Access Compliance Report

Public Rights-of-Way

Intersection ID: 8985	Main Street: ENNIS_AV	Cross Street: GRIMES_ST	Location: NE
ADA ID: D31607445937	Ramp Type: Directional2	Initial Pass/Fail: Fail	Overall Compliance: No
			Severity Score: 21.25

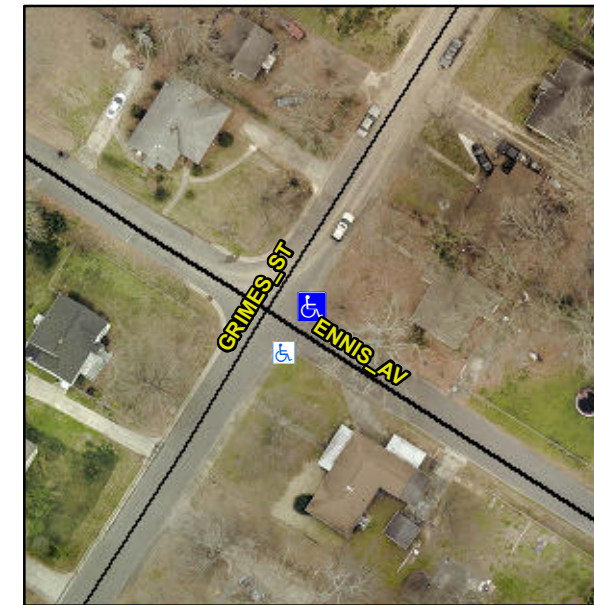
NO CURB

R304.5.1, R304.5.3

Compliance	Description	Data	Compliance	Description	Data
N/A	Ramp Length (in)	96.0	N/A	Grade Break?	N/A
No	Ramp Width (in)	38.0	N/A	Grade Break Slope (%)	0.0
Yes	Ramp Slope (%)	7.5	N/A	Grade Break XSlope (%)	0.0
No	Ramp XSlope (%)	6.8			
N/A	Flare Type LT	N/A	N/A	Flare Type RT	N/A
N/A	Flare Slope LT (%)	N/A	N/A	Flare Slope RT (%)	0.0
N/A	Flare Traversable LT?	N/A	N/A	Flare Traversable RT?	N/A
N/A	Landing Length (in)	0.0	N/A	DWS Provided?	N/A
N/A	Landing Width (in)	0.0	N/A	DWS Contrast?	N/A
N/A	Landing Slope (%)	0.0	N/A	DWS Length (in)	N/A
N/A	Landing X Slope (%)	0.0	N/A	DWS Full Width?	N/A
N/A	Landing Curb? (Y/N)	N/A	N/A	DWS Offset LT (in)	N/A
N/A	Shared Landing?	N/A	N/A	DWS Offset RT (in)	N/A
N/A	Gutter Ponding?	Yes	N/A	Gutter Slope (%)	N/A
N/A	Gutter Lip Ht (in)	0.0	N/A	Gutter X Slope (%)	N/A
N/A	Painted X Walk1?	No		Road Slope (%)	4.3
	X Walk 1 Direction	To SW		Road X Slope (%)	1.3
	X Walk 1 Width (in)	N/A		Clear Space?	N/A

Remove & Replace Entire Ramp.
